25 Murphy Street, Port Douglas - MCU (Multiple Dwellings)
Information request response (pursuant to Section 13 of the Development Assessment Rules)
Your Ref: MCUC 2023_5233/1

Information request response

Attachment A – Revised Proposal Plans

1 **Driveway Section**
Scale: 1:200

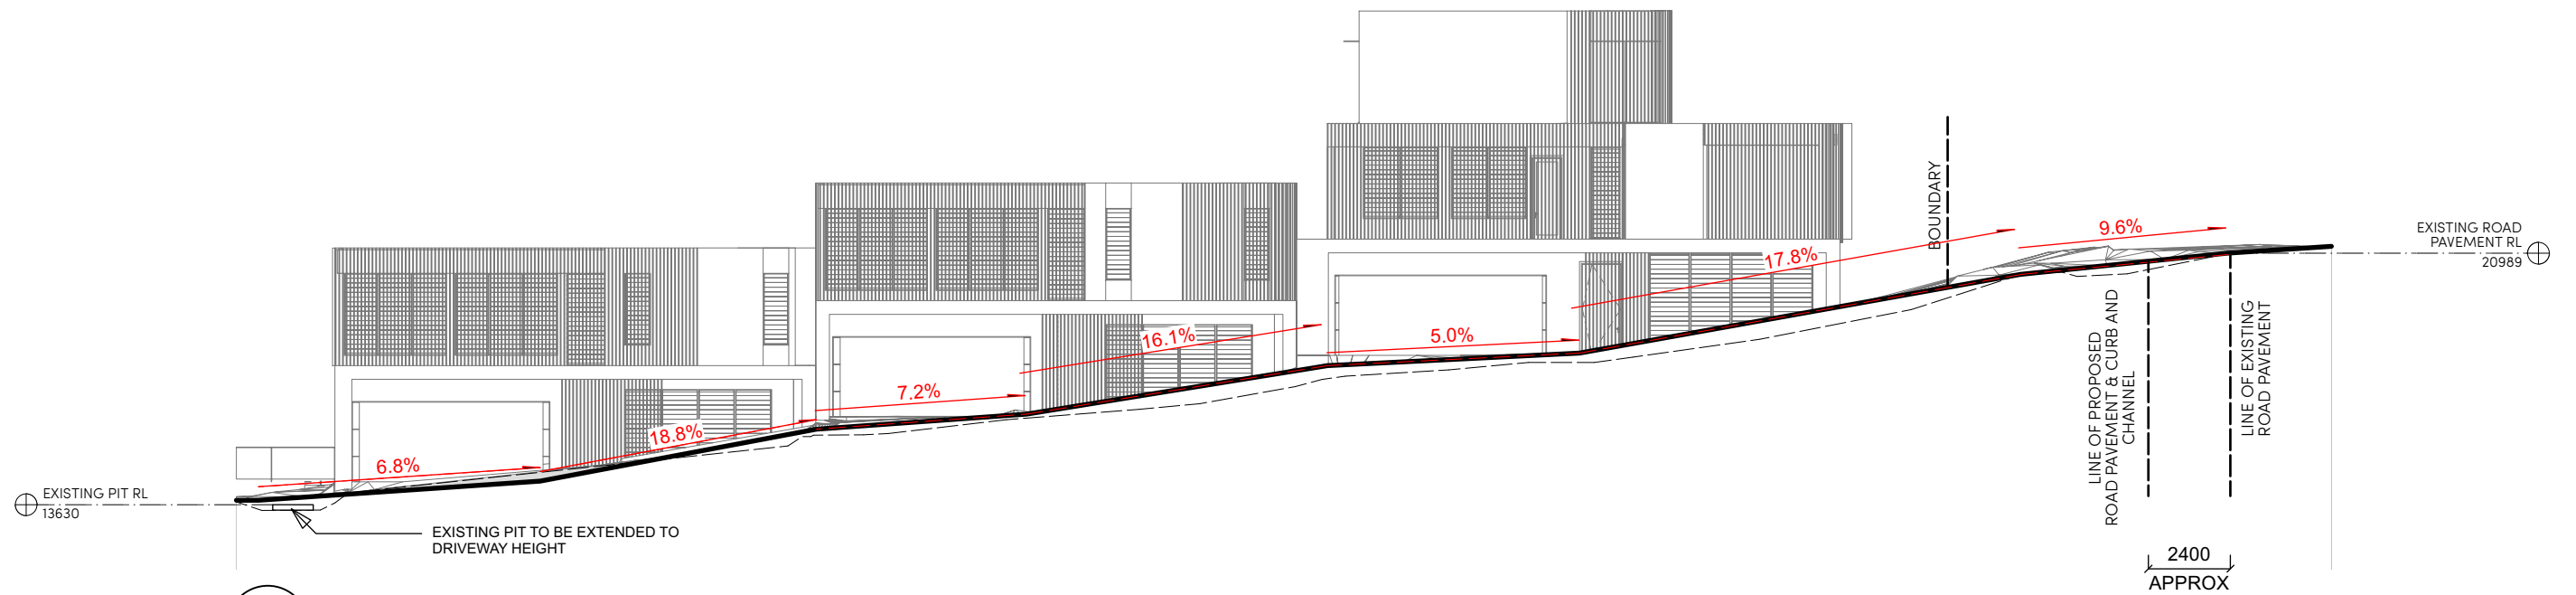
3. Please provide the following details for the driveway;
- a. Longitudinal survey and sections of the proposed driveway, including levels of the existing stormwater drainage pit within the proposed driveway, the existing and proposed road pavement;
 - b. Retaining walls must be identified and detailed; and
 - c. Identify how two vehicles pass one another on the internal driveway, particularly at the driveway entrance.
 - d. Provide swept path ingress and egress diagrams for each individual garage.

The existing ground level and the proposed driveway slope are provided on Drawing A301 submitted with the application. Notwithstanding, please find attached a longitudinal section of the driveway from the edge of the pavement within Murphy Street to the field entry pit at the rear of the site and adjacent the eastern side boundary.

2 **Cut / Fill Diagram**
Scale: 1:400

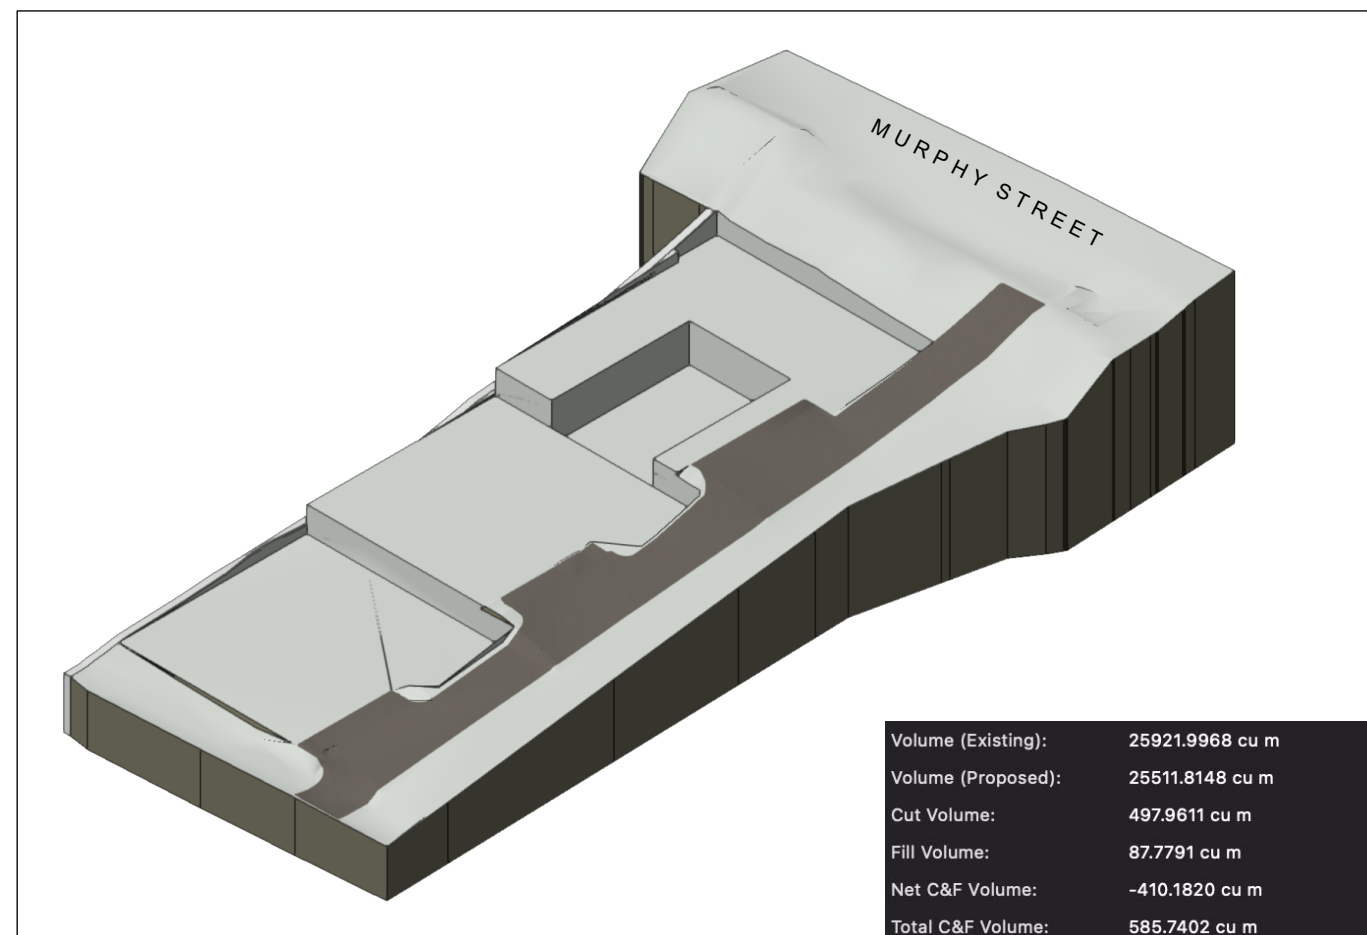
2. Please provide the following land surveys pre and post development for;
- a. The whole of the site, including neighbouring allotments and the adjacent road; and
 - b. Areas of the site nominated for cut and fill.

The drawings should clearly detail existing proposed ground levels and proposed heights for building/s, fences, pools, supporting and retaining structures, and the driveway.

Please find attached a detail contour and survey plan and a proposed cut and fill diagram identifying the extent of earthworks and retaining walls. Elevations of the retaining walls are shown in the plans submitted with the application and indicate a maximum height of 1.5 metres.

The retaining walls are illustrated on the elevations submitted with the application with more details provided on the cut and fill plan submitted as part of this response.

3 **typical eave detail bedrooms**
Scale: 1:50

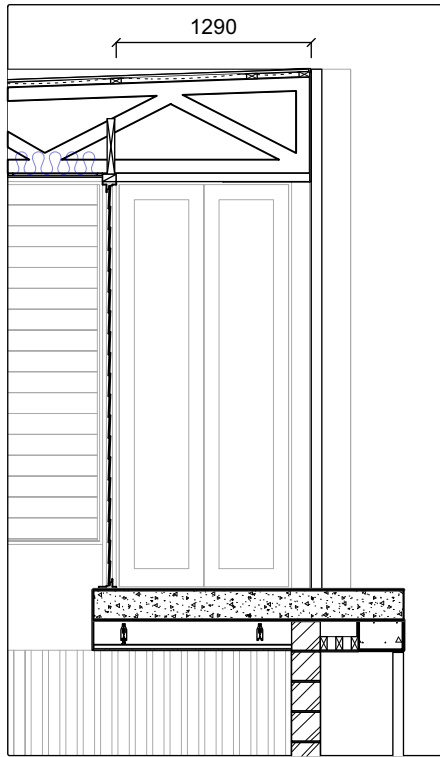
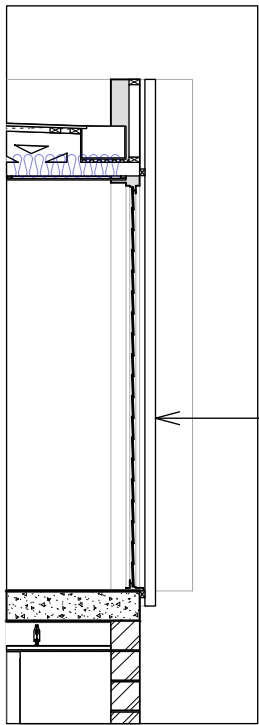
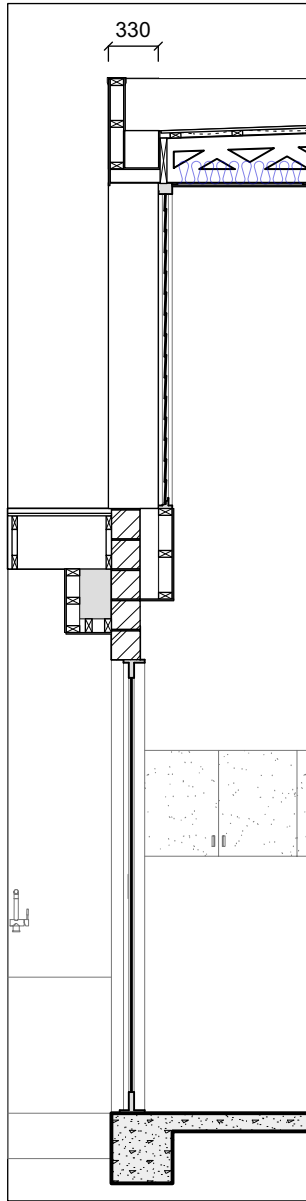
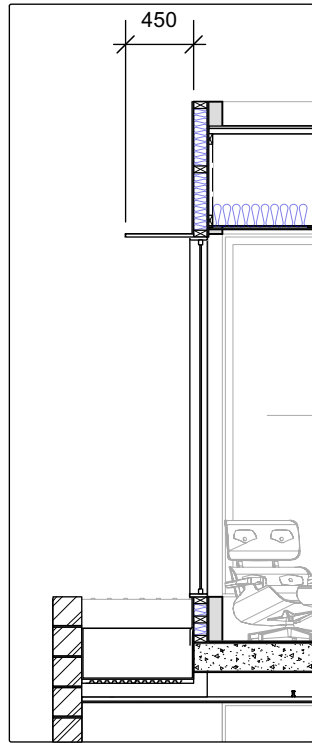
As a response to the tropical climate, the Planning Scheme advocates building design that incorporates elements such as pitched roofs and wide eaves, which also act to reduce the bulk of buildings. The proposed building design lacks these attributes, and the building bulk is accentuated particularly within the setback areas. Furthermore, although the aluminium battens provide some sun protection to the building, the treatment does not deliver rain protection to the windows, nor does it facilitate the circulation of air through the buildings.

The proposed development would provide eaves of 330mm -1290mm width over window openings, recessed windows with weather protection and a functionable and accessible outdoor alfresco area for each unit that that is accessible from the living areas. Attached are revised plans that include sections and highlight the tropical design elements, including wide eaves and protection form the inclement weather.
